DATE: December 23, 2024

ADDENDUM NO. 3

PROJECT NO. DGS C-0503-0027 PHASE 001
PROJECT TITLE - Danville State Hospital - Replace Steam Generation Equipment
PROFESSIONAL:

DRAWN BY Author	DATE 10-14-2024	SHEET No. A-3
CHECKED BY Checker	SCALE As indicated

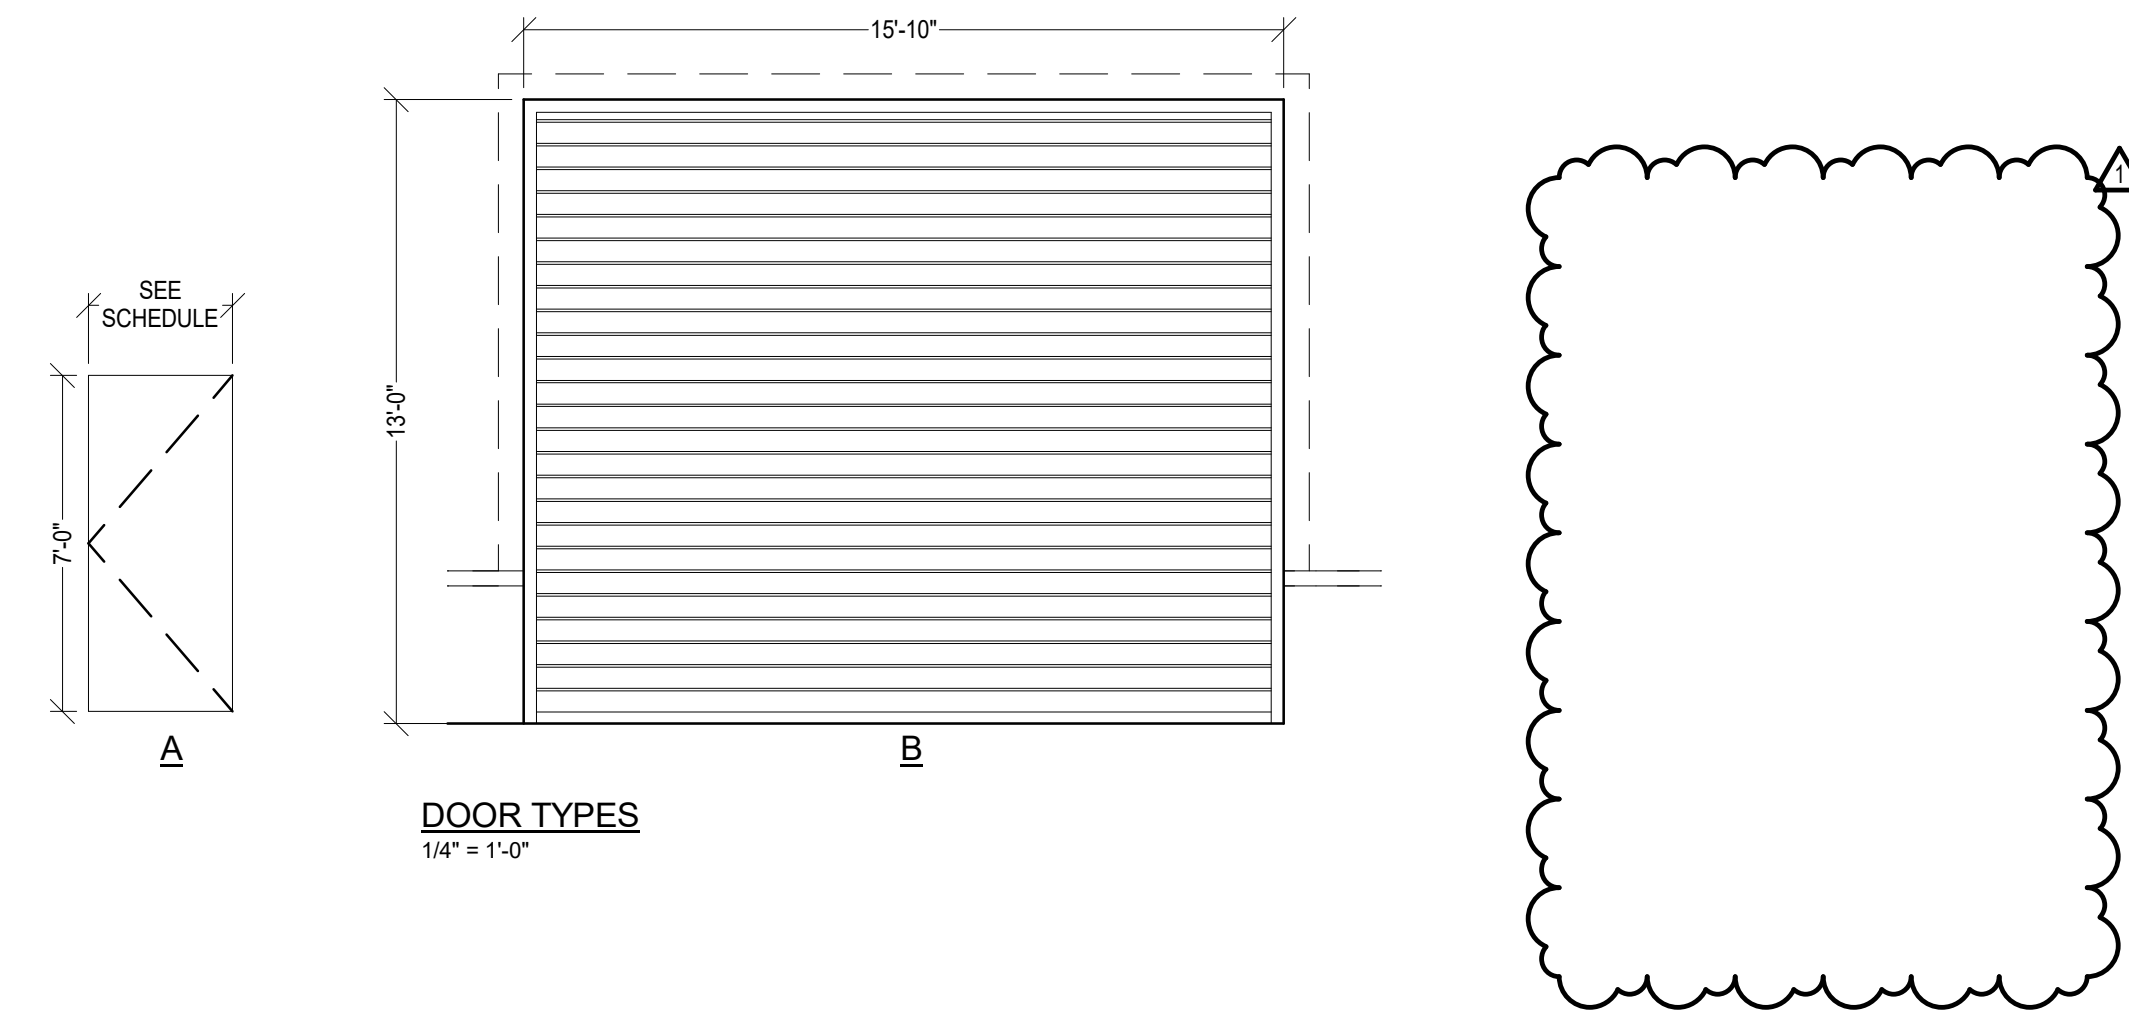
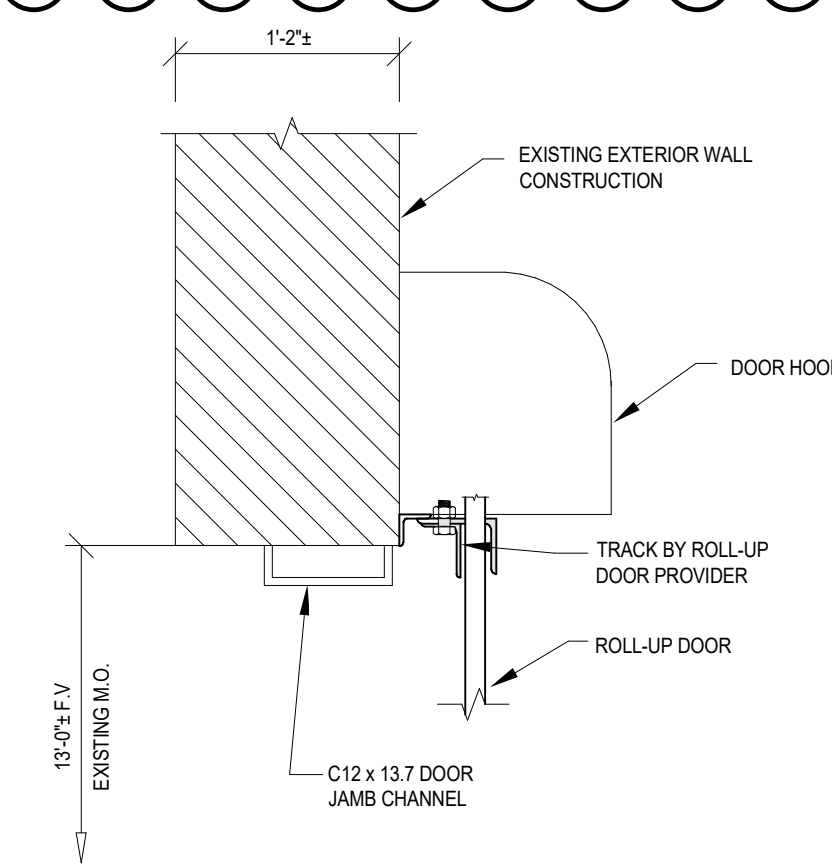
The facility is performing the installation work to install frame assembly for the man door as noted on drawing A-3. This portion of work is removed from the scope of the project. Drawings A-3 has been revised to remove frame details.

DRAWN BY: JV
CHECKED BY: RBR
DATE: 10-14-2024
SCALE: As Indicated
SHEET No. H-5

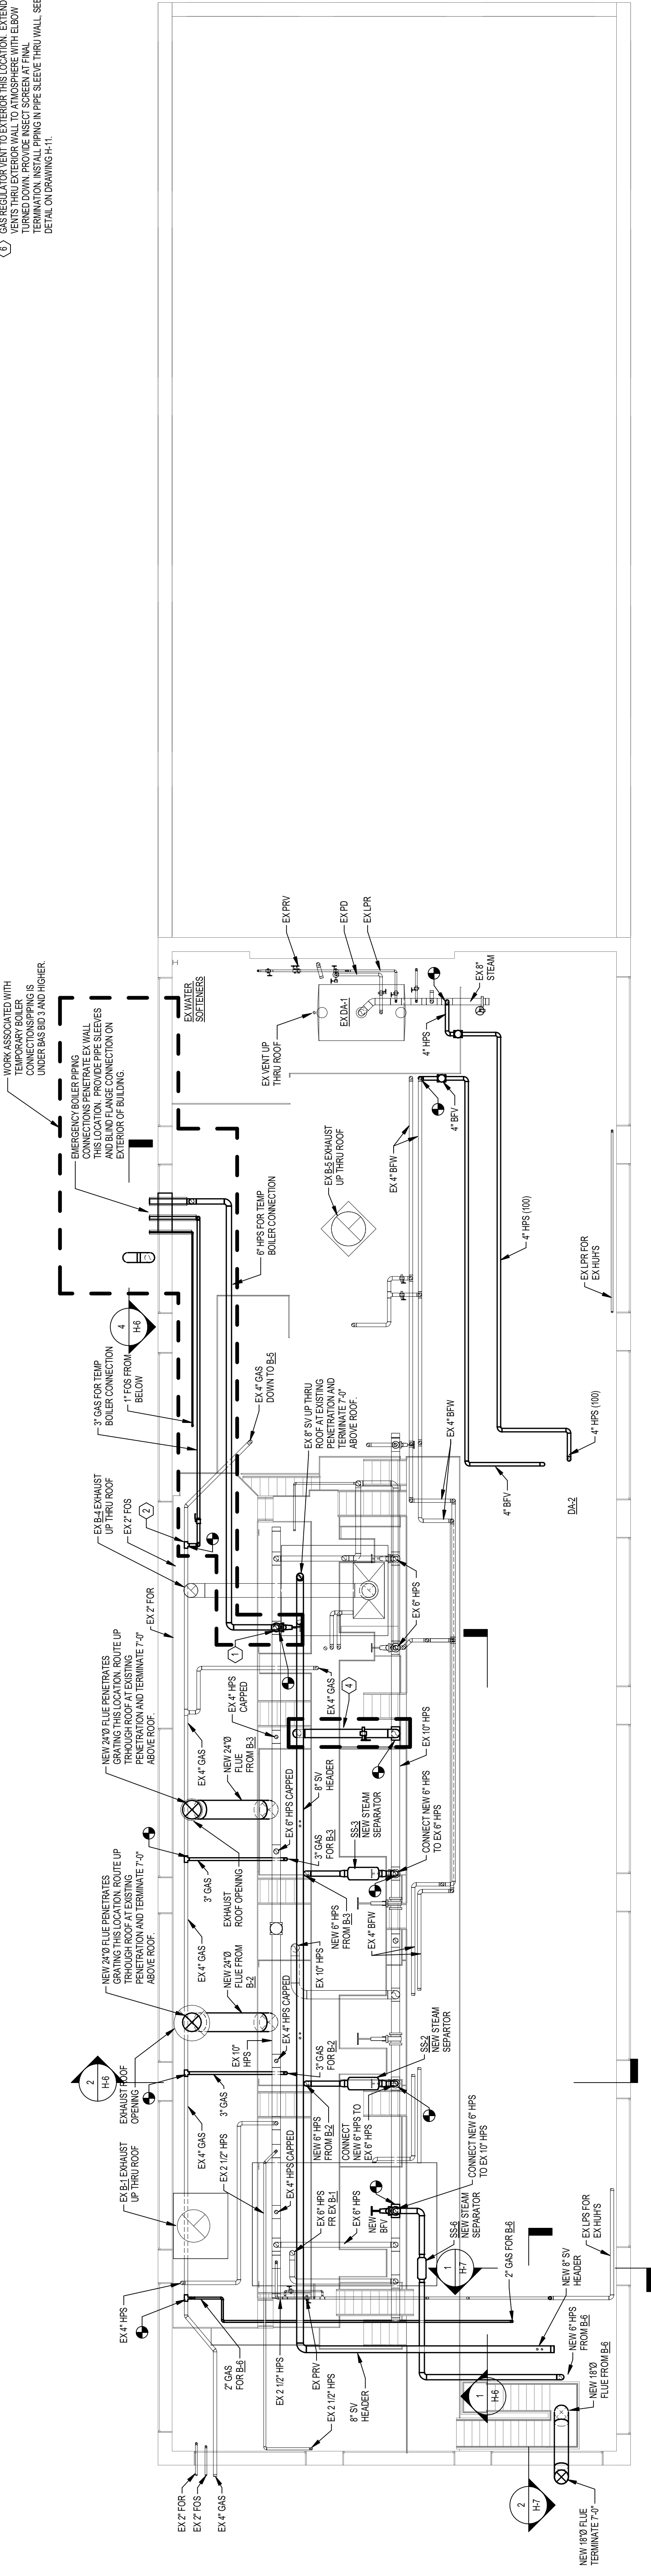
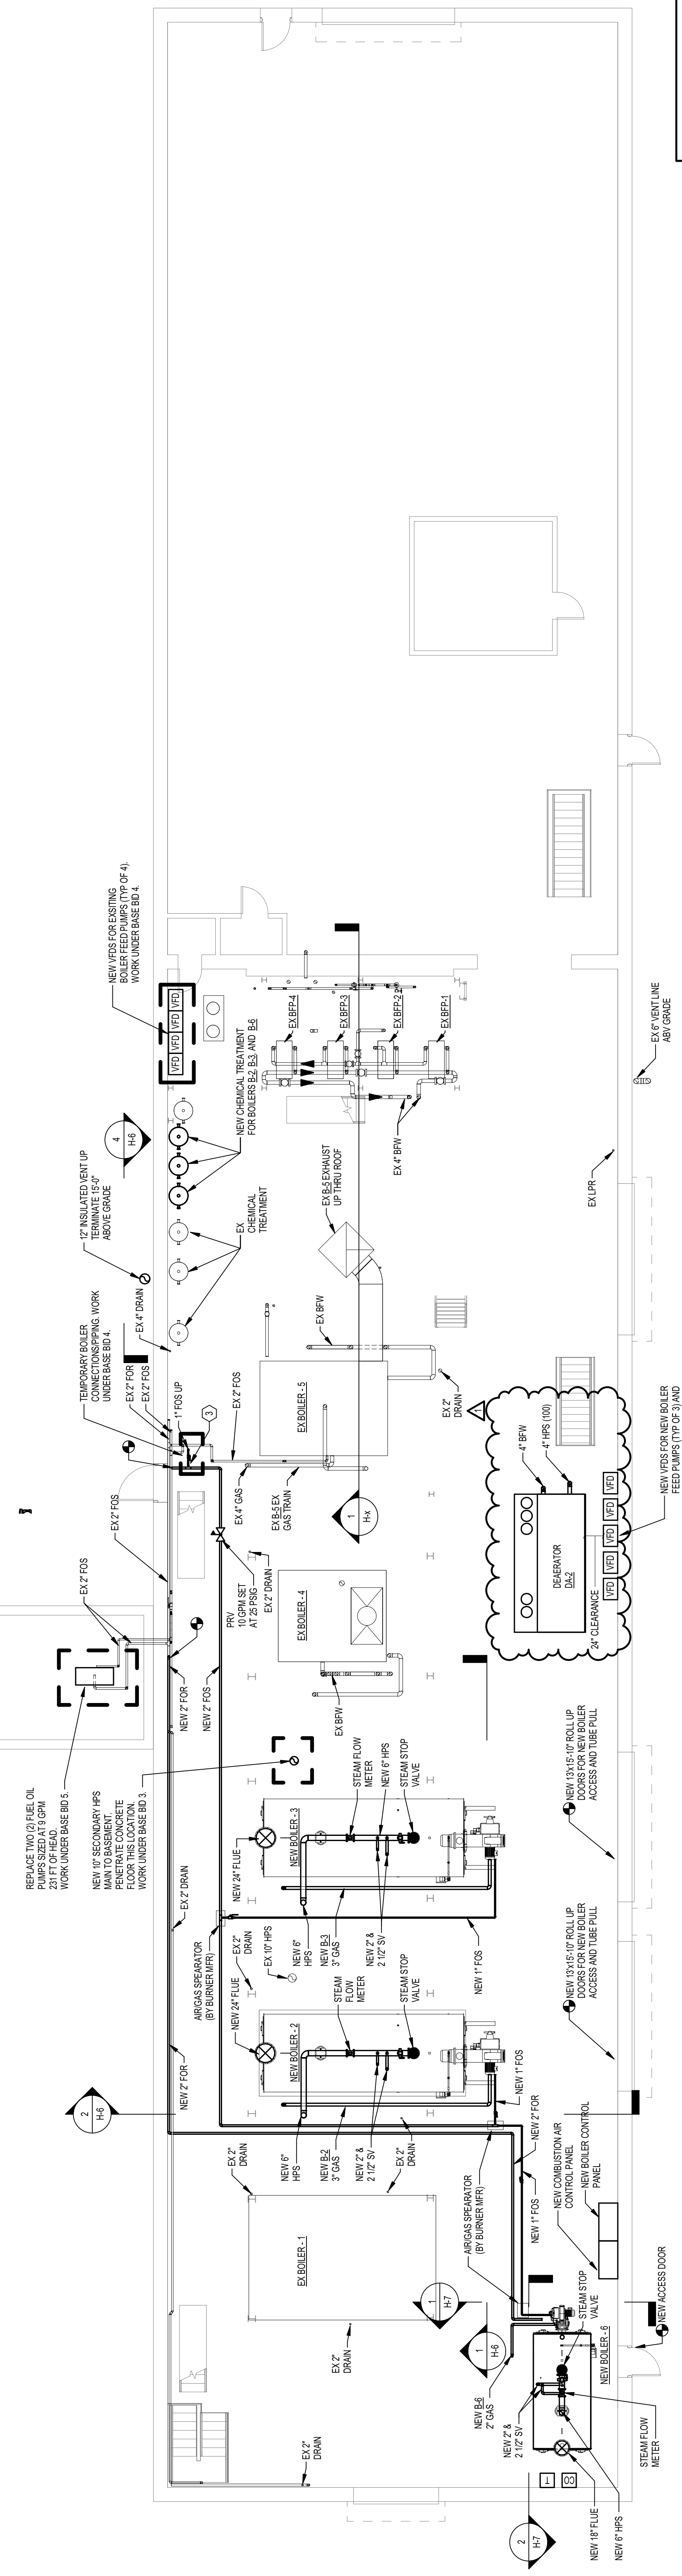
Drawing H-5 has been revised to show the correct dimensions of the new combination deaerator and surge tank DA-2.
